**Response to Request for Additional Information
DA/2024/763, 559 Anambah Road, Gosforth**

The purpose of this letter is to respond to the items raised in the City of Maitland Council Request for Information (RFI) dated 6 February 2025 in relation to DA/2024/763 for Concept Development Application for Two (2) into Nine Hundred (900) Lot Staged Torrens Title Subdivision, and Stage 1 Torrens Title Subdivision of Two Hundred and Forty-One (241) Lots at 117/DP874171 & 55/DP874170 generally known as 559 Anambah Road, Gosforth.

Figure 3 Example Loop Road Configuration

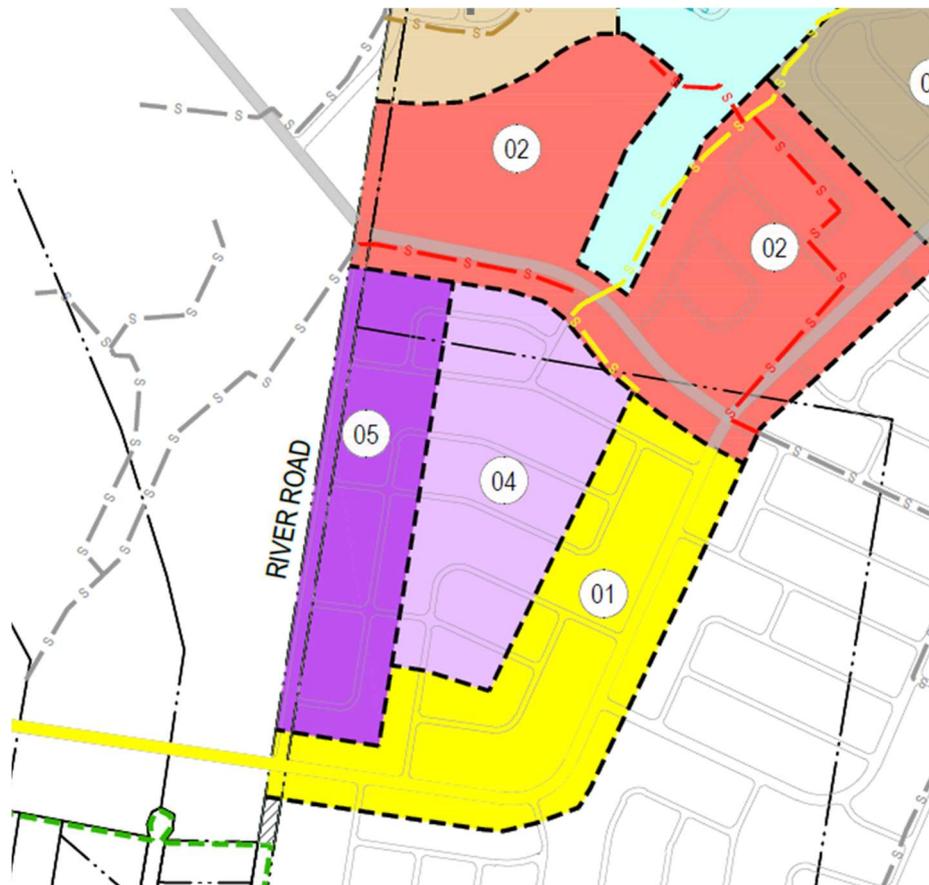
The configuration of the future public roads could be constructed in such a way that create public road loops that link with River Road, so that if River Road were to be closed for upgrade, maintenance or removal that an alternate public road access to New England Highway could be maintained during construction. This would ensure continuity of access. For example, the figure below provides a good example of how loop roads could be constructed and delivered to provide continual access while River Road was developed.

In the Figure above, taking Stage 5 as an example, River Road traffic could be diverted around Stage 5 as the public road network for Stages 2 & 5 will have already been constructed. This would provide continuity of access in emergency prior to any works on River Road occurring.

Figure 5 - Hunter River 1 in 5 yr ARI (18% AEP)

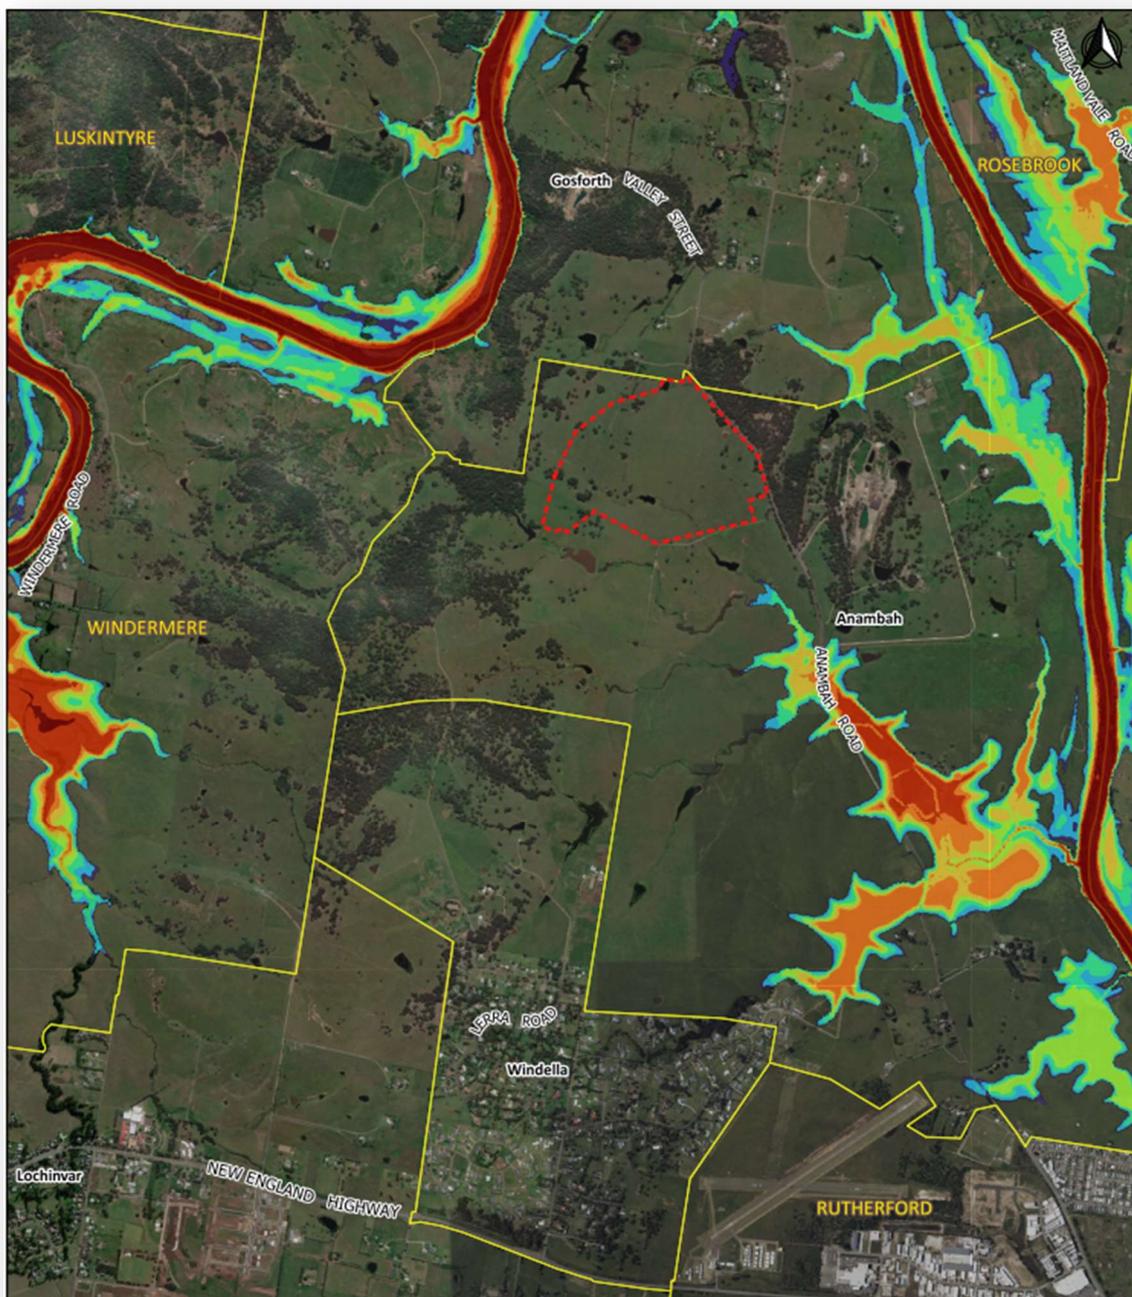
These figures show that inundation of Anambah Road commences somewhere between the 39% AEP (1 in 2 year ARI) and 18% AEP (1 in 5 year ARI). Interpolation indicates inundation would occur approximately 1 in every 2.4 years based on a long-term average. Taking a conservative approach to duration, during the design storm for the 18% AEP, Anambah Road is cut for approximately 44 hours. Based on this duration and average frequency of isolation, Anambah Road is estimated to be cut approximately 0.2% of the time. This means that River Road would only need to be utilised as an alternate access for flood less than 1 day per year (or less than 8 days in a 10-year period).

There is no other data to indicate that River Road would need to be used more frequently for emergency events other than flooding. Council has specifically raised the concern of bushfire risk, however, Anambah Road generally runs through cleared grazing land and would not be expected to be subject to a high or prolonged bushfire risk. As such, Anambah Road is not expected to be cut off as a result of bushfire events for an extended period of time.

Figure 8 Concept Anambah Road Intersection Treatment

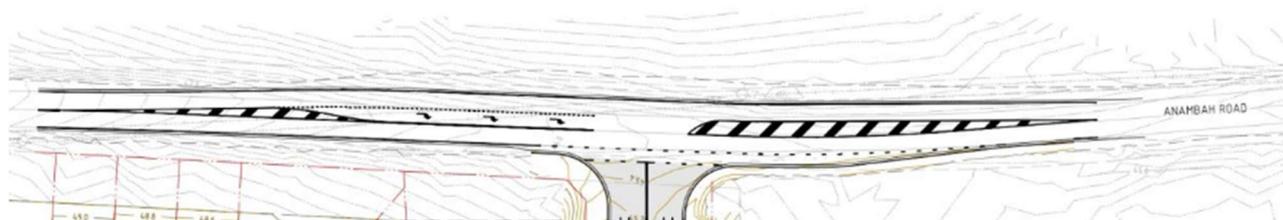
d) Minimal detail has been provided around the suitability of the intersection selected off Anambah Road. Including design, Level of Service, Safety assessment, etc. Noting the posted speed limit in the area is 100km/h, meaning a 110km/h design speed poses a major safety concern having an urban environment access this road with an inadequate intersection.

A response to the RFI has been prepared by Northrop and is included in the Engineering Report in the supporting documentation. The intersection with Anambah Road will form the primary road access for the site. Intersection upgrade works are proposed to facilitate the connection of the subdivision entry road with Anambah Road and will be completed concurrently with Stage 1 of the development.

- Basic left turn BAL treatment for north-bound, left turning traffic.
- Short lane channelised right turn CHR(S) treatment for south-bound, right turning vehicles.
